State of New Jersey
Department of Environmental Protection and Energy

Re: Naval Weapons Station Earle (NWSE)
Colts Neck Township, Monmouth County
Site Investigation (SI) Work Plan

The Department of Environmental Protection and Energy (DEPE) has reviewed the above referenced document. The DEPE's comments are as follow.

NEW JERSEY DEPARTMENT OF ENVIRONMENTAL PROTECTION
 MONITORING WELL SPECIFICATIONS AND REQUIREMENTS
 FOR UNCONSOLIDATED FORMATIONS

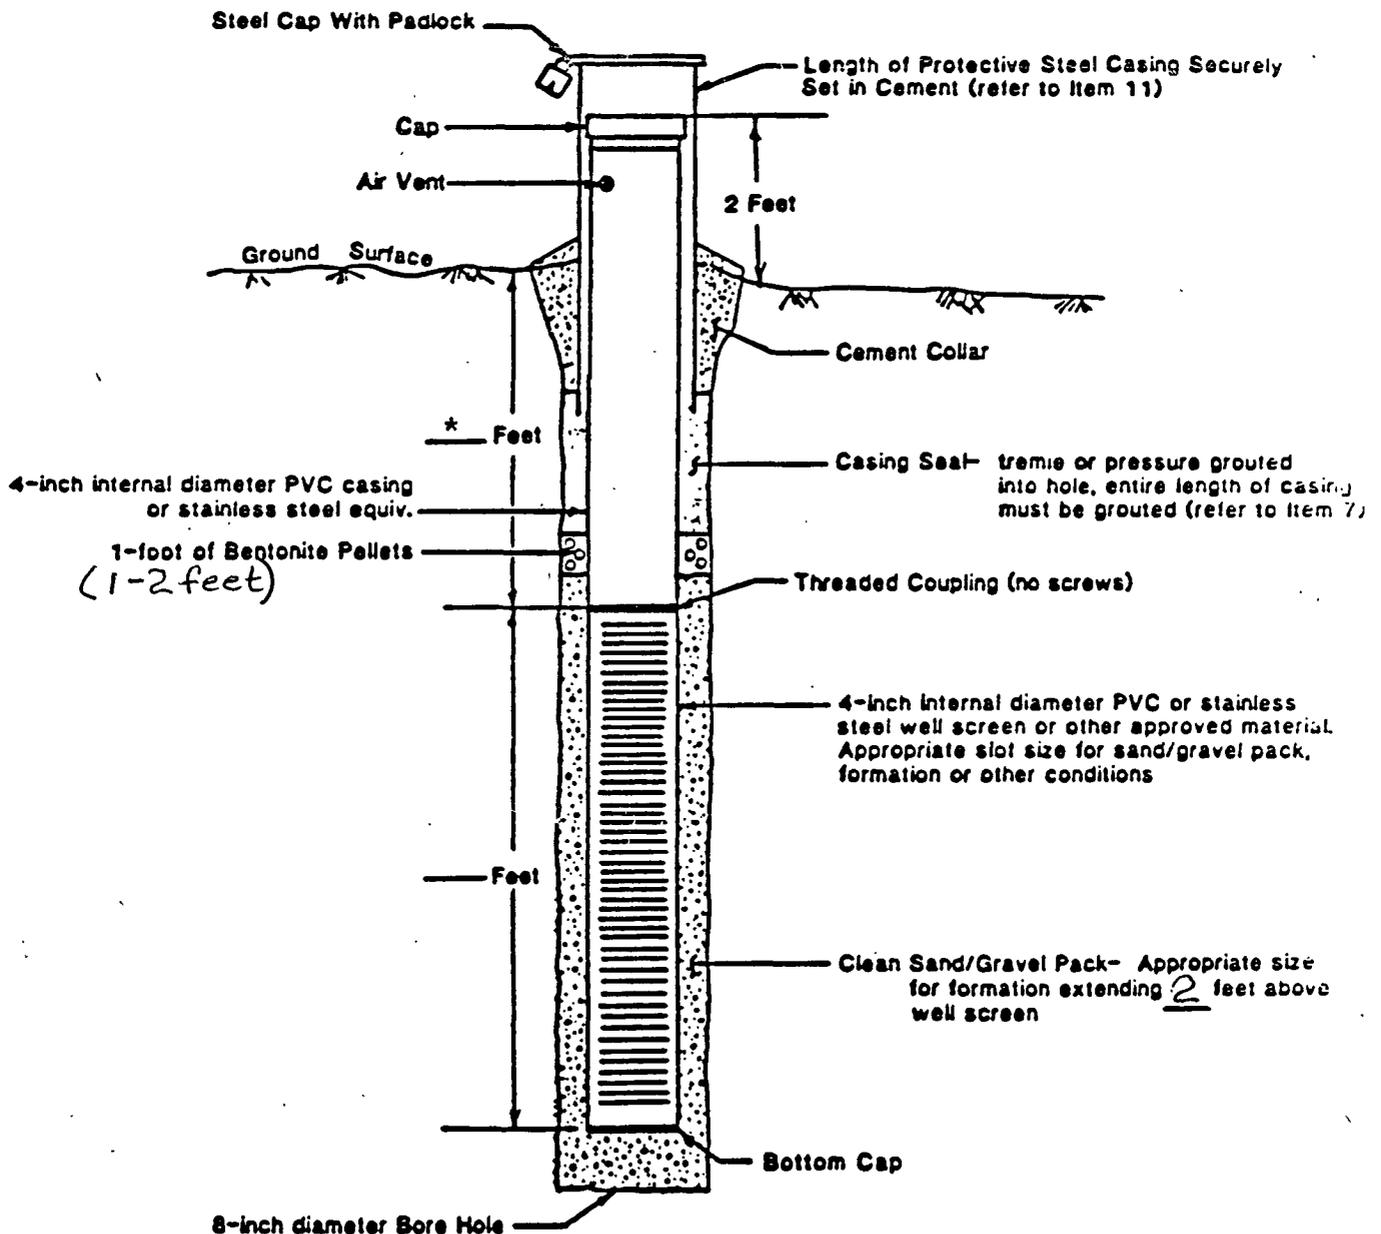
Monitor wells at the NWSE will be installed according to the NJDEPE Monitor Well Installation Specifications (attached). Furthermore, Morie Sand must be used instead of Ottawa sand. The sand pack will be overlain with 1 -2 feet of bentonite pellets. If these pellets are installed above the water table they will be installed in 6-inch lifts with an appropriate hydration interval per lift allowed.

FIGURE 1: AERIAL PHOTOGRAPH ANALYSIS SHOWING SURFICIAL CHARACTERISTICS OF SITES 6, 12, 15, AND 17, NWS EARLE, COLTS NECK, NJ

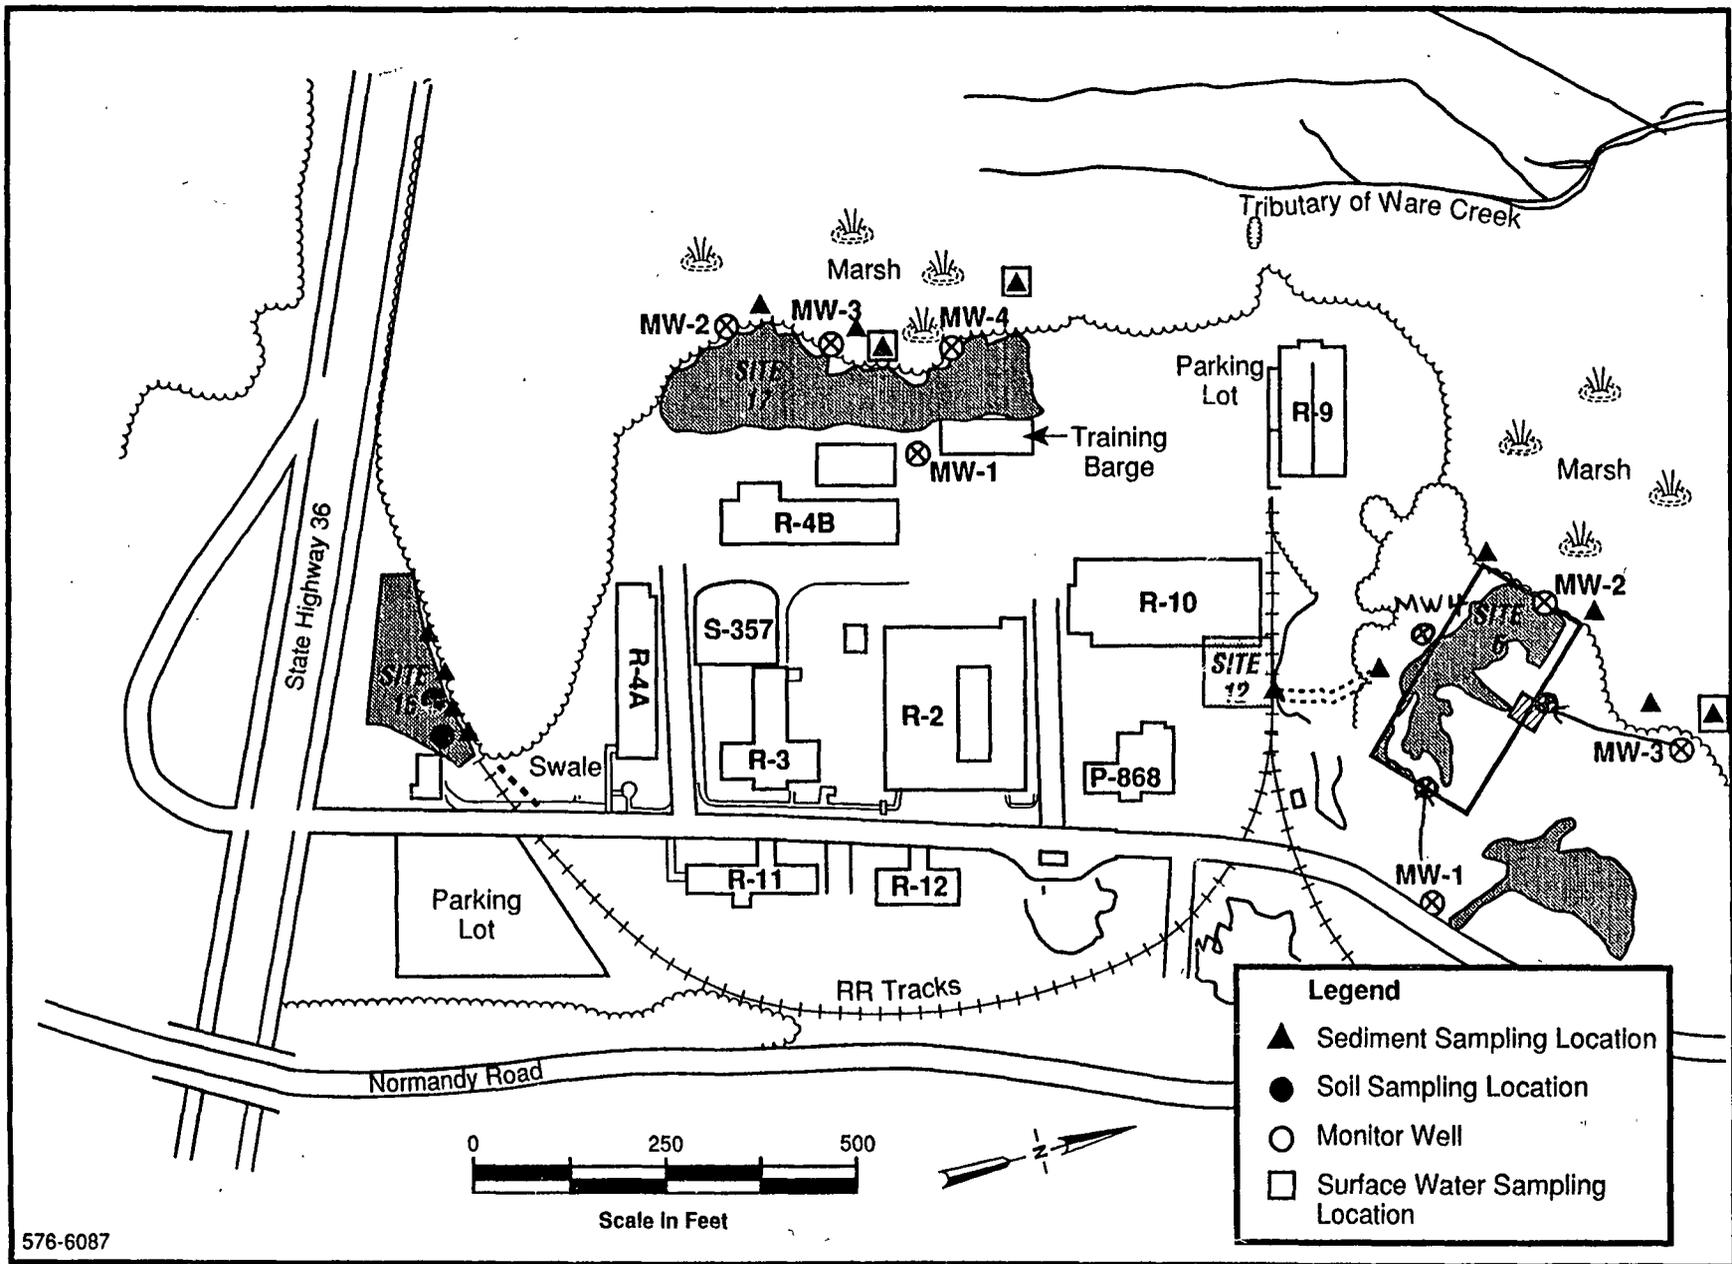
It is proposed that three monitor wells be installed at Site 6. Due to the size of Site 6, DEPE requires that four monitor wells be installed at the locations shown on Figure 1.
